Source: T1
Title: CRs to TS 34.123-3 (TTCN part, Cat. B) v.3.7.0, for approval
Agenda item: 5.1.3
Document for: Approval

This document contains the CRs to TS 34.123-3 v.3.7.0. These CRs have been agreed by T1 and are put forward to TSG T for approval.

4.3 cds_RB_RelSpeech_CS_SigConnRel (WA#RRC4574)

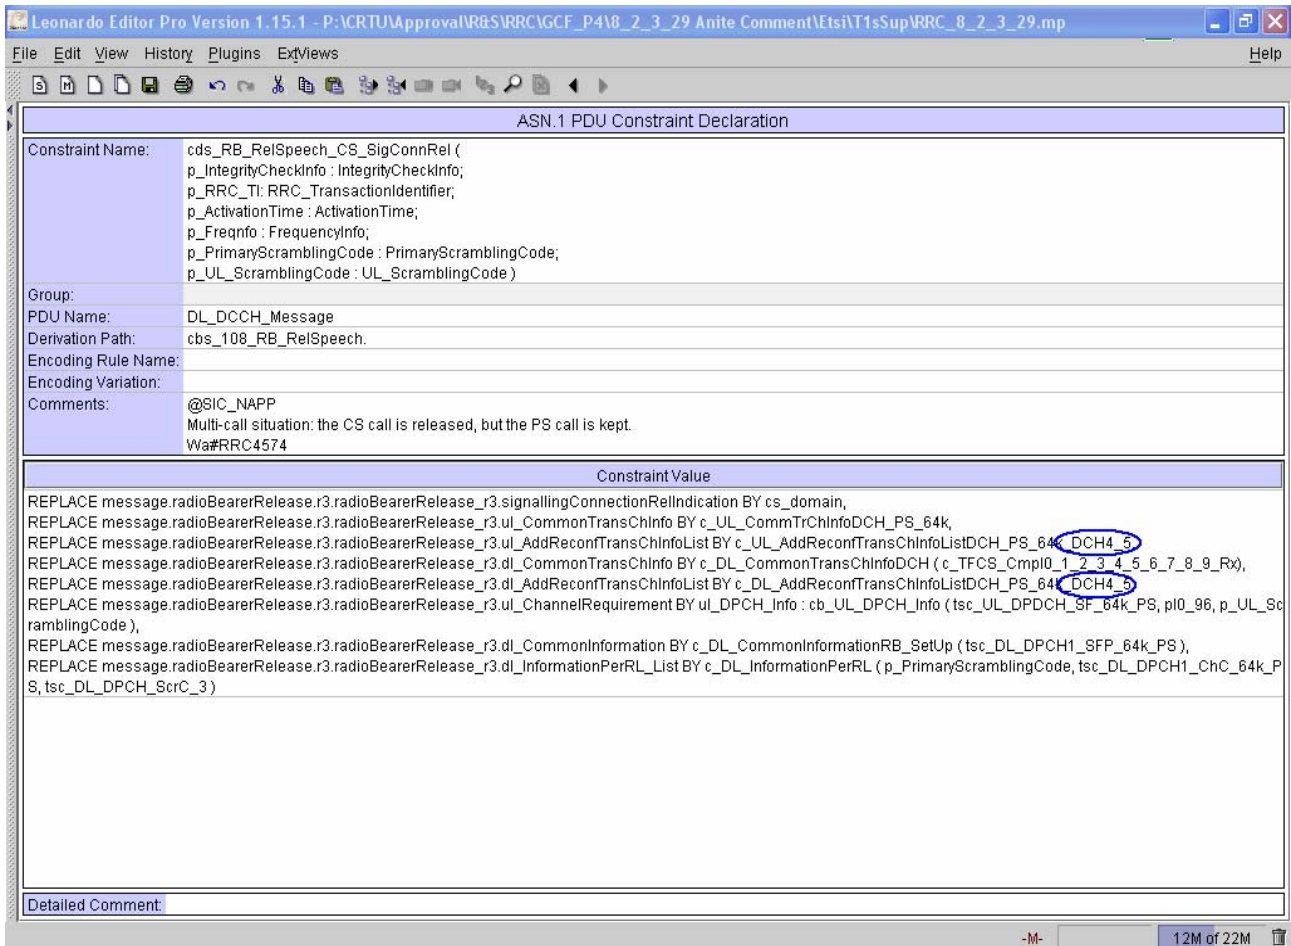
Test step name cds_RB_RelSpeech_CS_SigConnRel
Reason for change When setting up the initial RAB Set up message for CS RB 10,11,12 are mapped to DCH1,DCH2, & DCH3. The PS RAB RB 20 is mapped to DCH4.

Therefore in order to be consistent with the RAB setup configuration, the Radio Bearer Release message should specify DCH4 in the UL/DL Addrconfig Transport Channel Info List.
